REQUEST FOR INFORMATION DATE: June 07, 2016 NO.: RFI-156

Project Name: 15051-Webster University Interdisciplinary Science Building Project No.: 15051

Subject: Feeding fin tube heaters from panel 2NH1

REQUEST FOR INFORMATION **DATE:** June 02, 2016 **NO.:** RFI-144

M0102.B

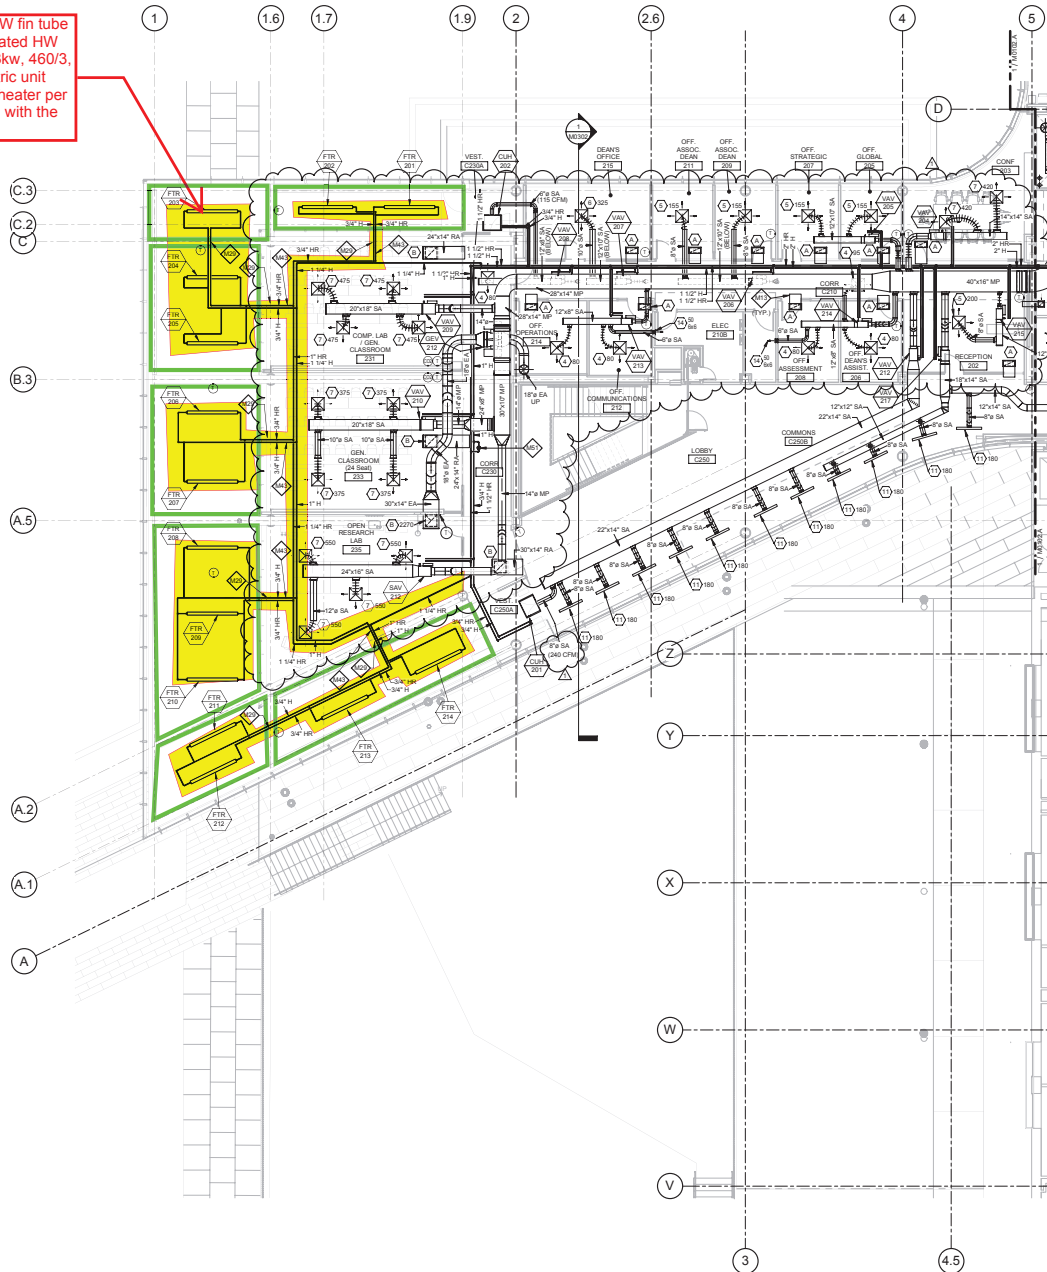
Can the underfloor HW fin tube radiation be eliminated and replaced with seven (7) electric plenum rated unit heaters?

Suggestion: We propose to replace the hot water radiation in the 2nd floor overhang with electric unit heaters due to the freeze, burst and water damage potential. This recently occurred in the St. Louis area where a small controls glitch prevented the control valve, serving the fin tube, from opening and caused the pipes to freeze and burst resulting in extensive water damage. By replacing the hot water piping with electric heat, the threat of water damage is eliminated. There are many variables that could cause this piping to freeze, system glitch, control valve failure, future controls programming changes, etc..

This proposal includes seven (7) 3kW, plenum rated, electric unit heaters to replace the HW fin tube and associated piping. Unit heaters will come with local thermostat control and can be set to the desired setpoint for the underfloor heat.

Proposal to replace HW fin tube radiation and associated HW piping with seven (7) 3kw, 460/3, plenum rated electric unit heaters. One (1) unit heater per "pocket", highlighted with the green box.

Yes, heating water finned tube radiation can be replaced with plenum rated electric unit heaters. Provide access for maintenance, electrical power, and controls. Also include BAS alarms if any unit heater fails or if plenum space temperature approaches freezing temperatures to protect sprinkler lines.
